ADDENDUM No. 1 TO PLANS AND CONTRACT DOCUMENTS

**EAST MARSH ISLAND MARSH CREATION
POST-CONSTRUCTION MAINTENANCE EVENT**

CWPPRA NUMBER: TV-21

APRIL 4, 2014

TEMPORARY ROCK
PLUG REMOVAL &
BREACH REPAIR

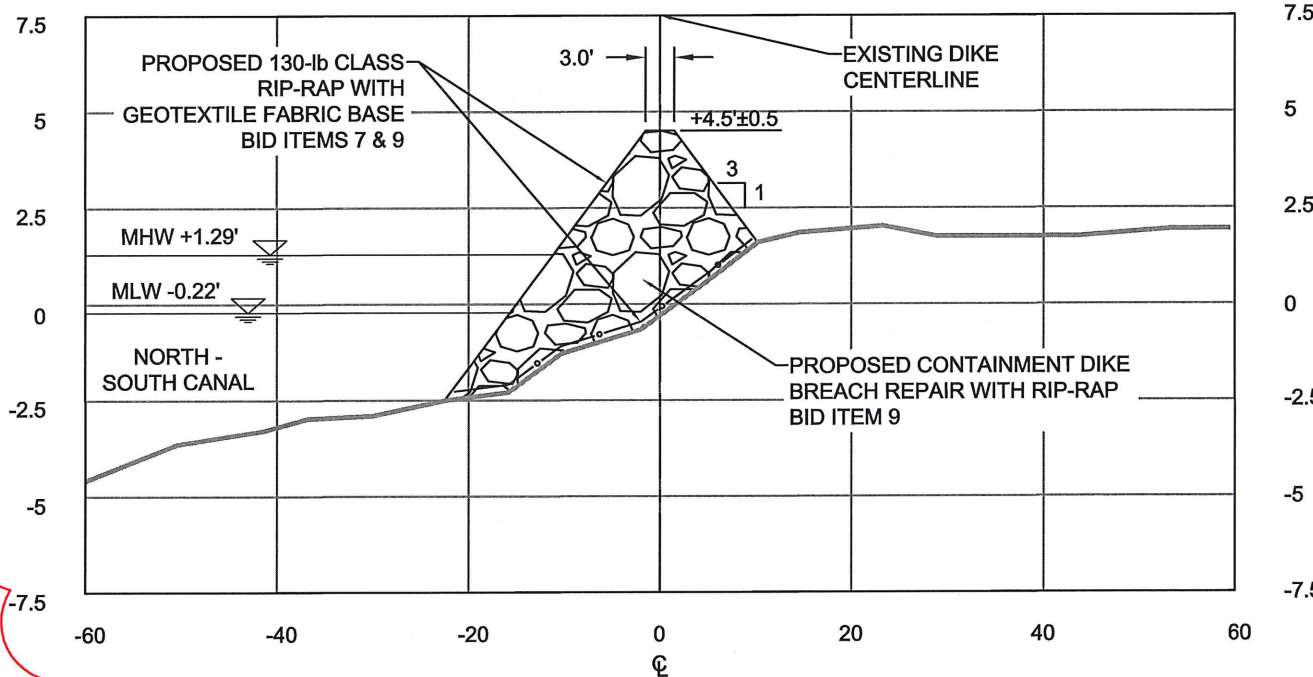
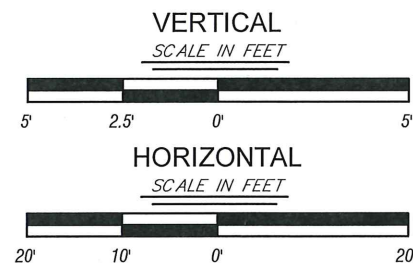
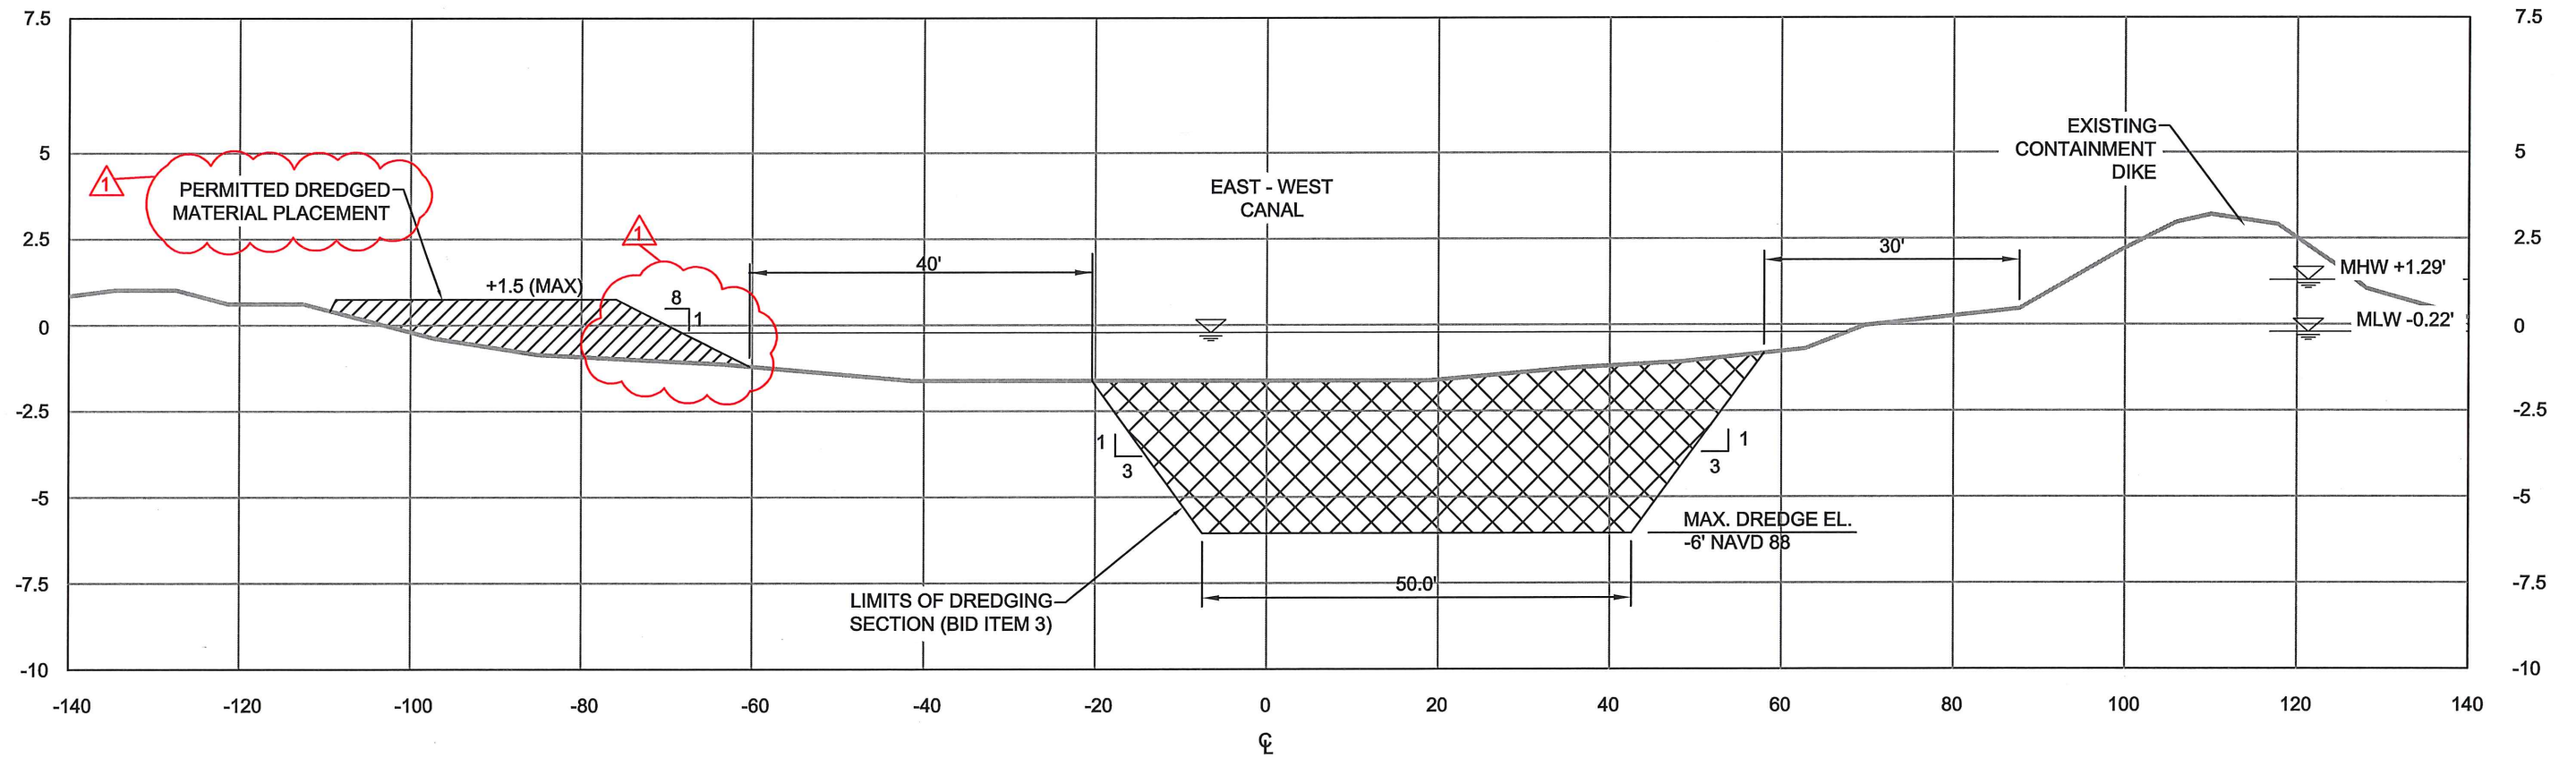
- 1.1. The Plans and Specifications will be updated to clarify the material replacement of the rock plug shall be **to** the pre-construction surveyed lines, grades, and elevations.

- NOTES:**
1. TYPICAL SECTIONS OF EXISTING FEATURES ARE NOT BASED ON SURVEY DATA.
 2. TEMPORARILY REMOVED ROCK PLUG MATERIAL SHALL BE PLACED WITHIN THE EXISTING ROCK PLUG EXTENTS.
 3. THE ROCK PLUG MAY ONLY BE EXCAVATED TO A MAXIMUM ELEVATION OF -6.0' (NAVD88).
 4. THE PLUG SHALL BE DEGRADED FOR A MINIMUM OF 50.0' ALONG THE EXISTING ROCK PLUG CENTERLINE.
 5. THE CONTRACTOR IS RESPONSIBLE FOR LOCATING AND AVOIDING EXISTING PIPELINE AND OIL AND GAS INFRASTRUCTURE DURING DEGRADEMENT.
 6. THE EXCAVATED ROCK PLUG MATERIAL SHALL BE PLACED WITHIN PRECONSTRUCTION LINES, GRADES, AND ELEVATIONS PRIOR TO DEMOBILIZATION.
 7. TYPICAL SECTION E-E SHALL FOLLOW DETAILS FOR ARTICULATED CONCRETE MAT INSTALLATION SHOWN IN SHEET 12.
